### ELECTRIC LANDING GEAR - CIRCUIT PROTECTION

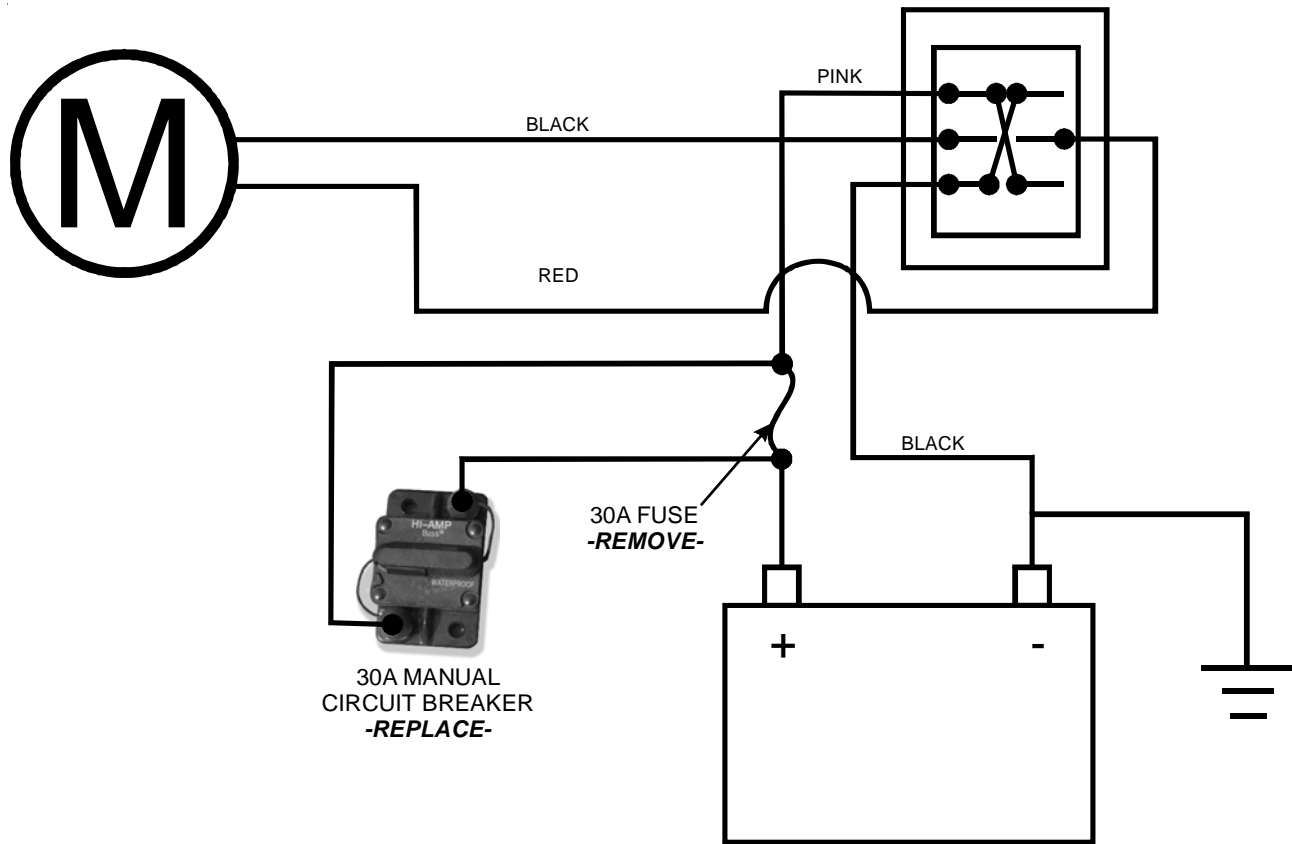
The Lippert Components, Inc. Electric Landing Gear Switch and Harness is supplied stock with a 30A inline fuse on the power lead to the switch.

It is acceptable for the 30A fuse to be removed and replaced with a 30A manual circuit breaker. If any of the wiring is removed and discarded along with the fuse, exact gauge and quality wire must be used to replace the preexisting wire.

Replacing the 30A fuse with the 30A manual circuit breaker does not void Lippert Components, Inc. Limited Warranty and is RVIA compliant. However, in the event of the system becoming inoperative or damaged initiating from the condition, quality or installation of the 30A manual circuit breaker, the liability lies with the installer of the breaker.

It is understood that this revision can be performed under the permission of Lippert Components, Inc. but is not a recommended operation or replacement.
